DRAWINGS – REVISION 1

DMVA PROJECT NO. 42230136 For BUILDING 16-153 RENOVATION

'REVISION 1' includes the following drawing sheets and notes.

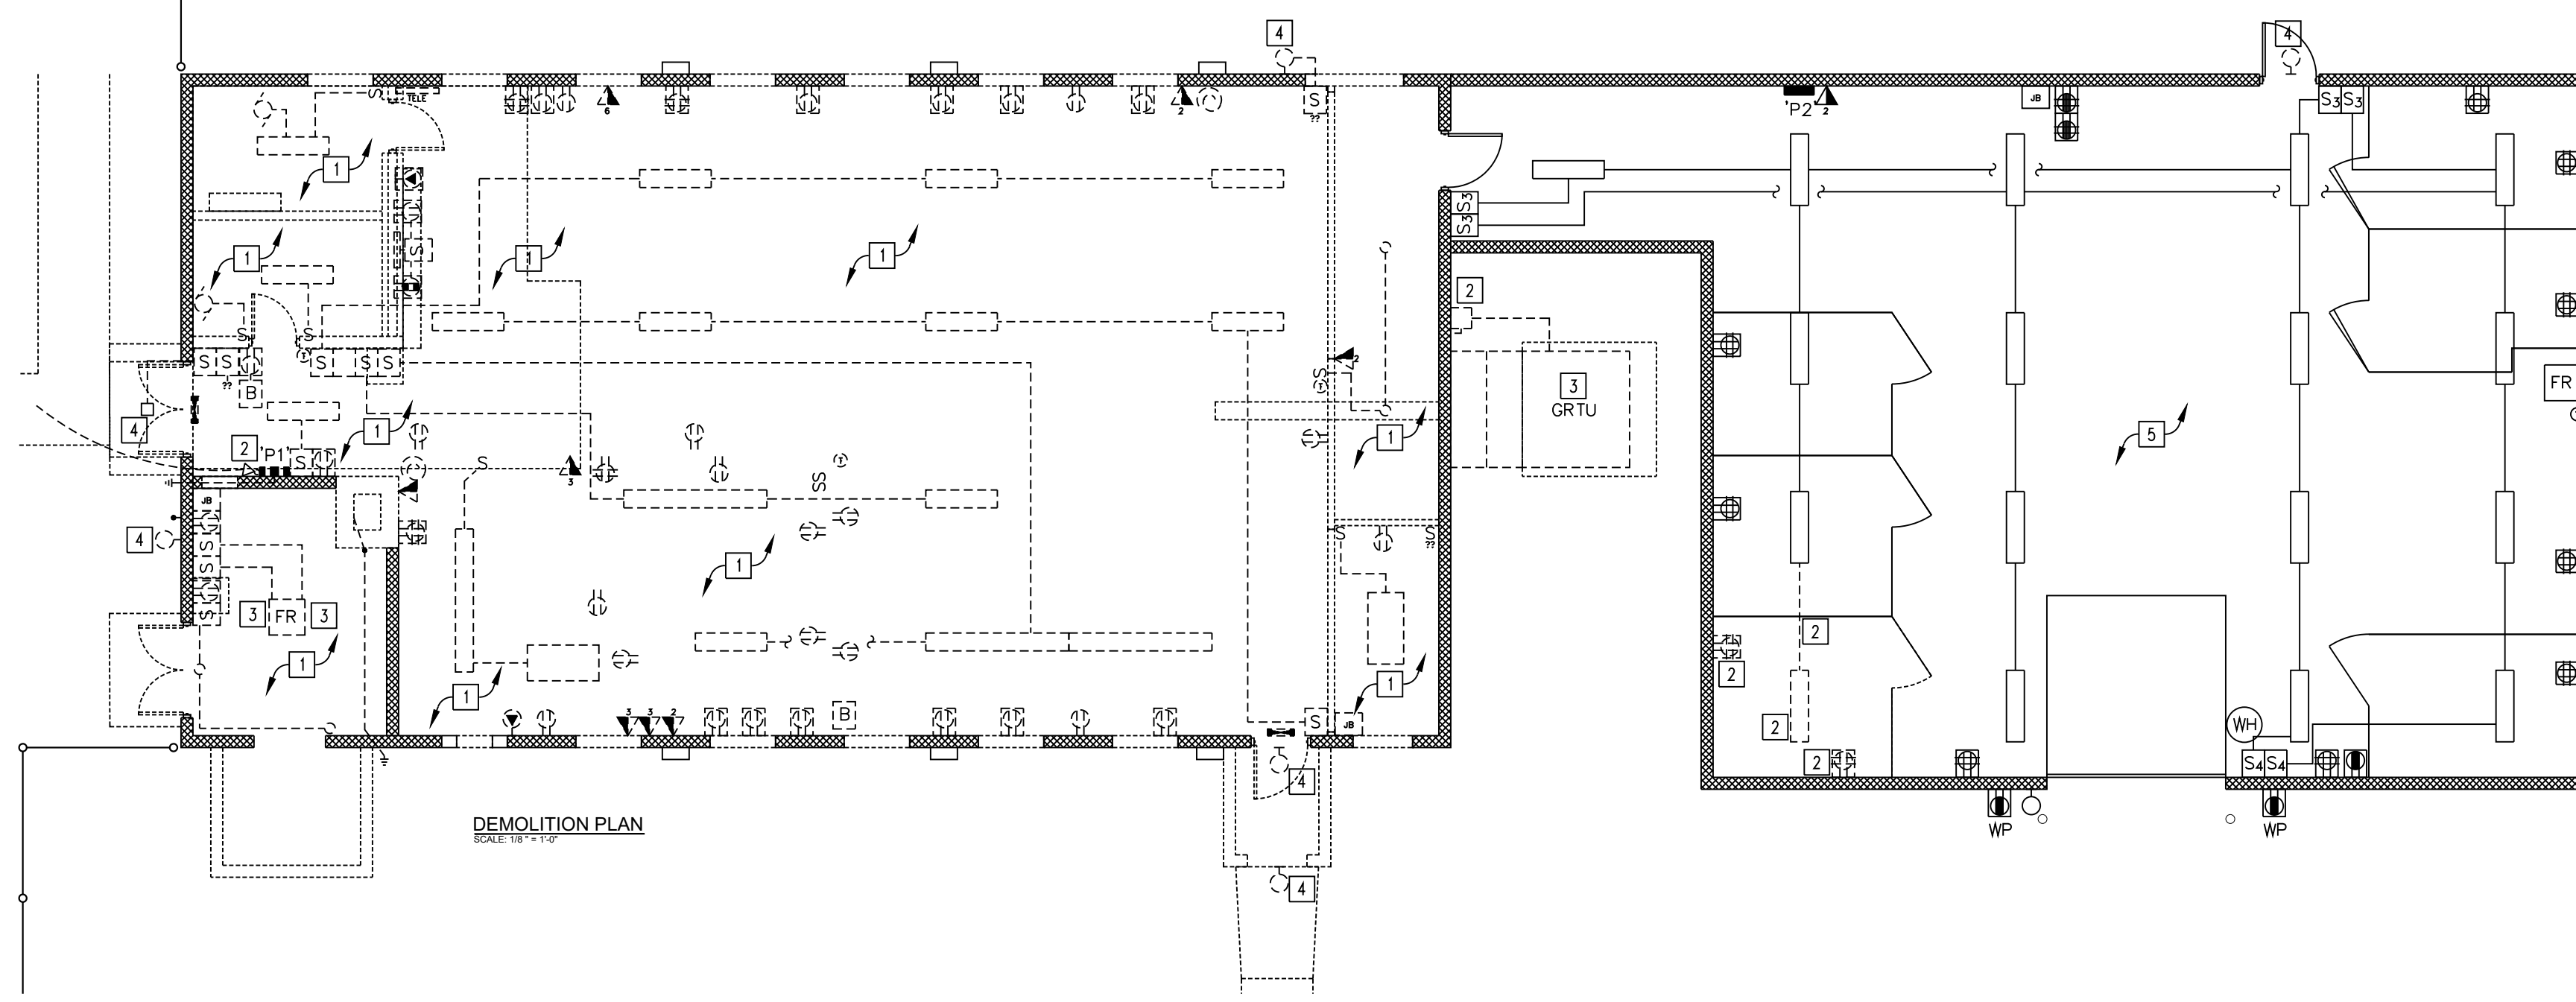
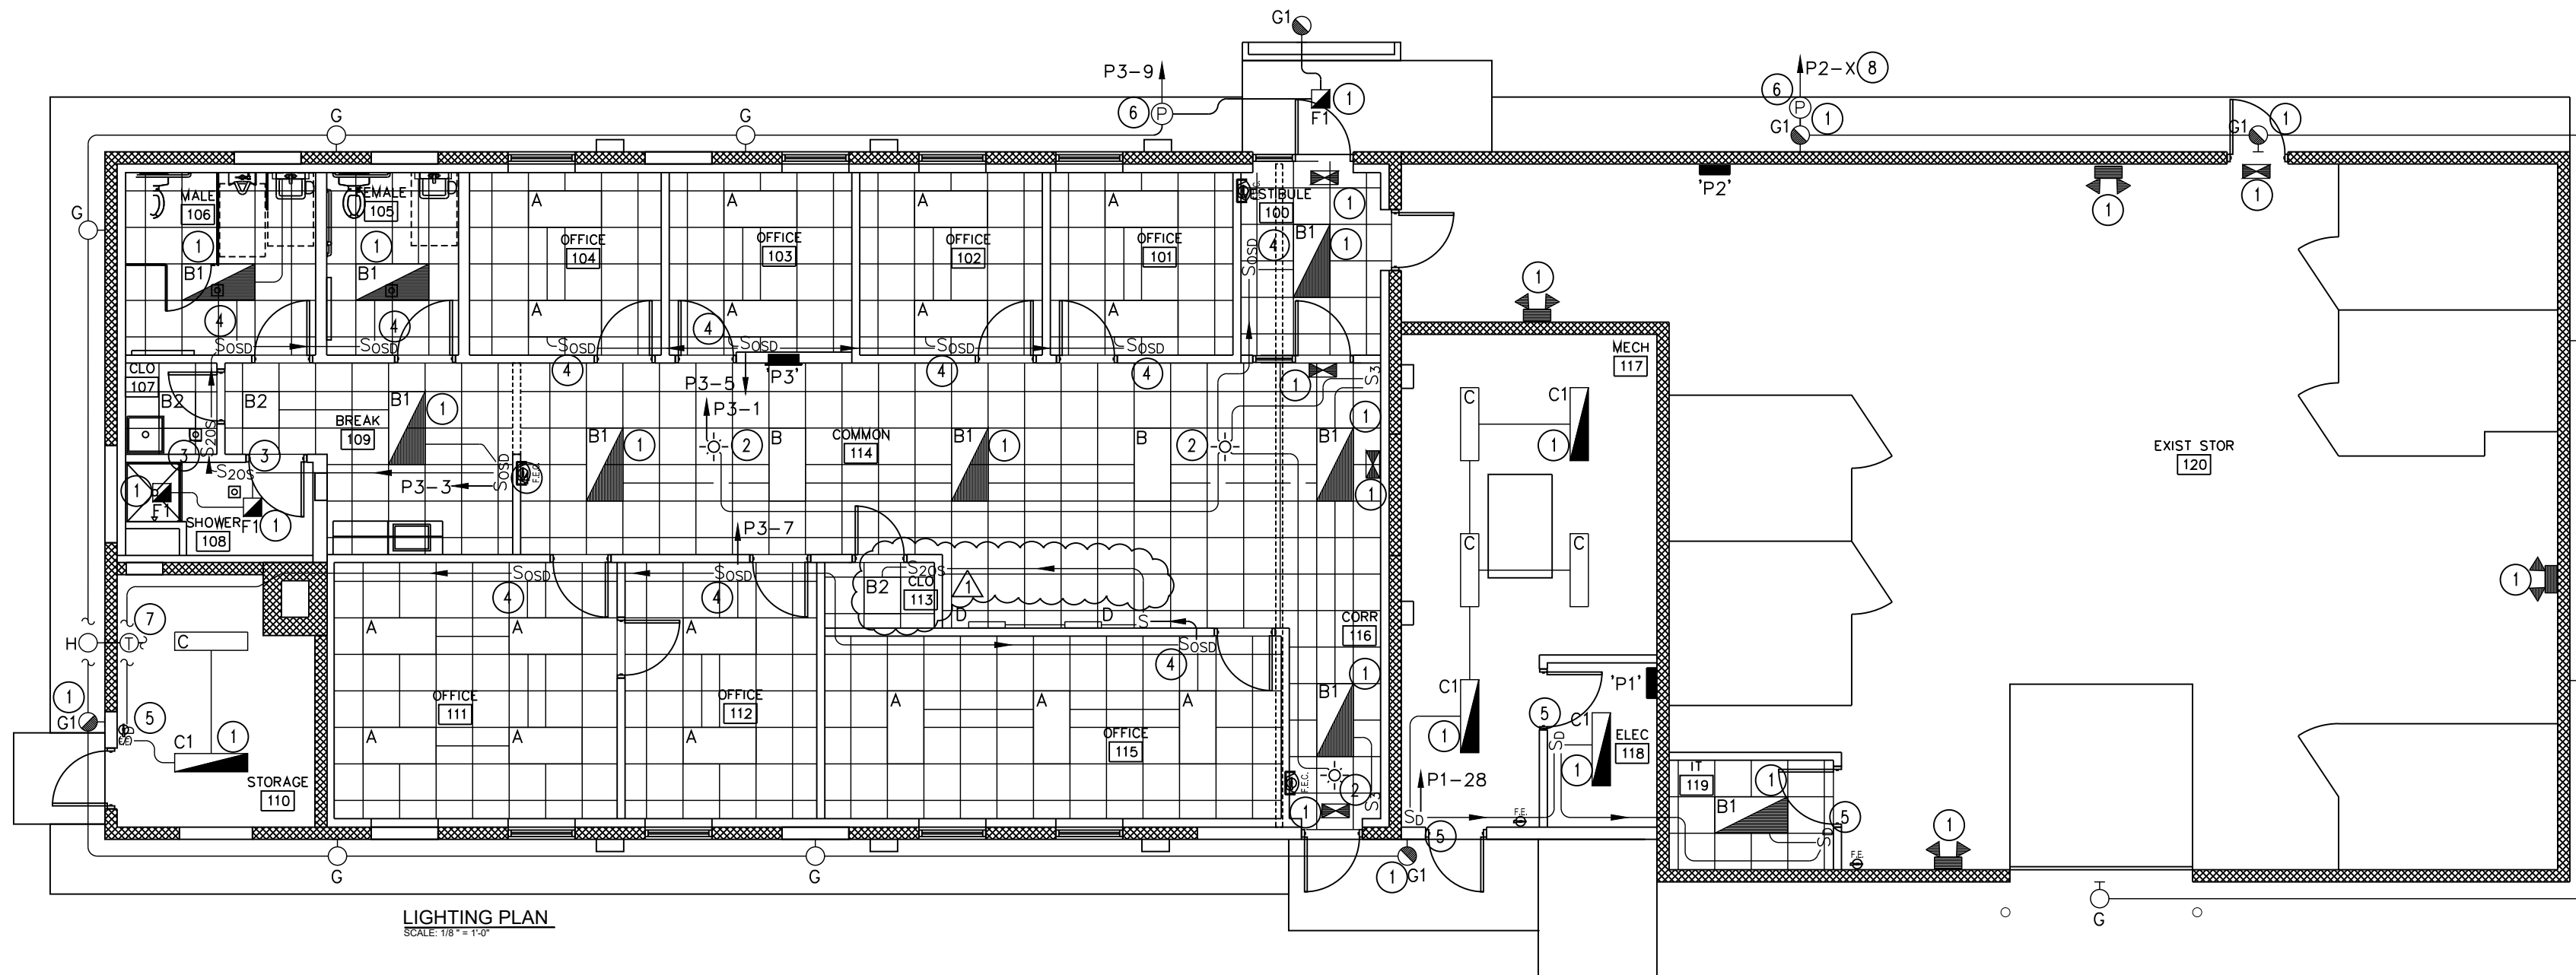
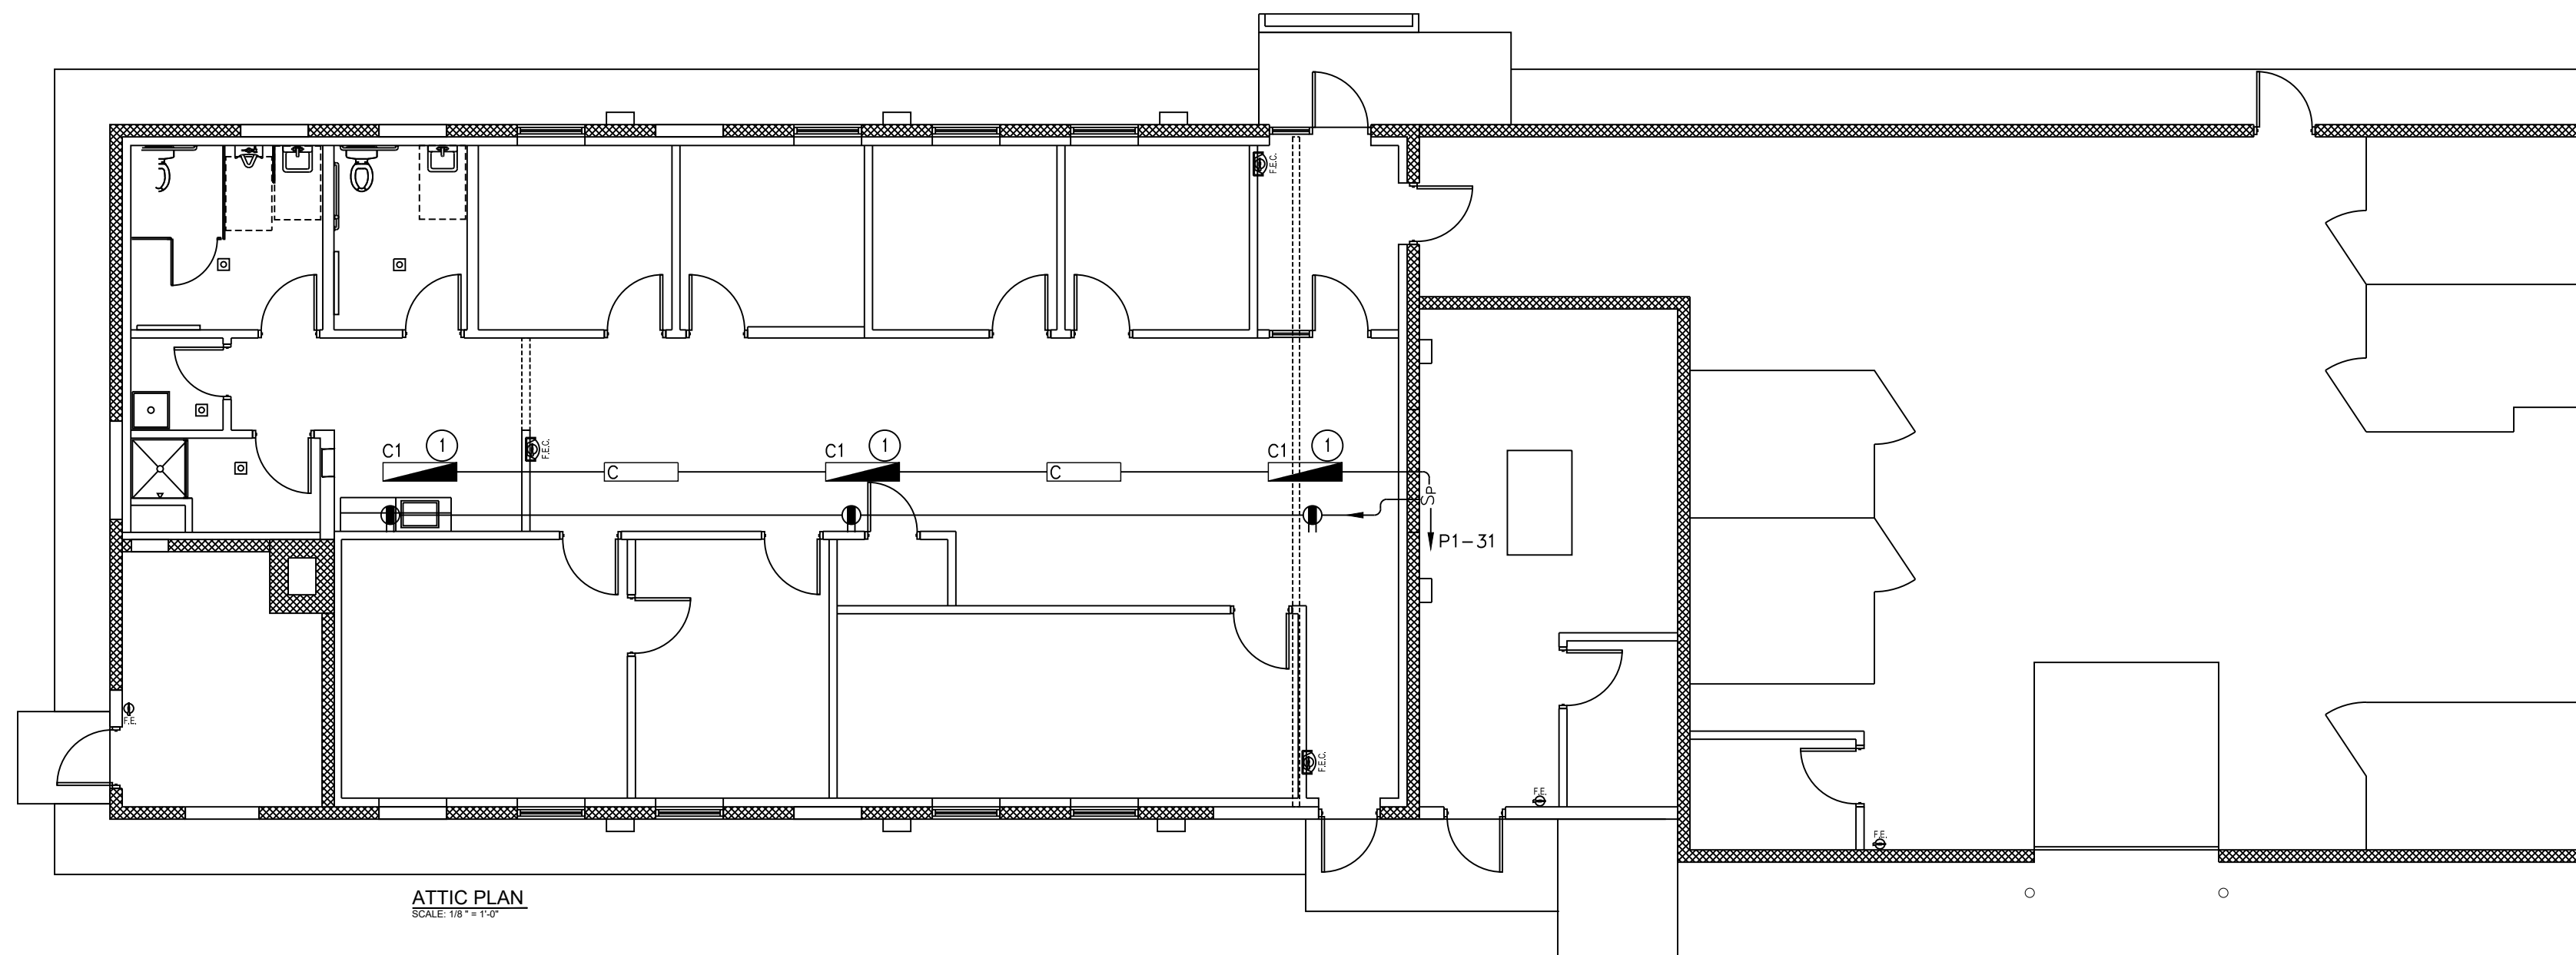
NO.	DESCRIPTION	DATE
1	ADDED OCC SENSOR - CLARIFICATIONS	5 APR 24
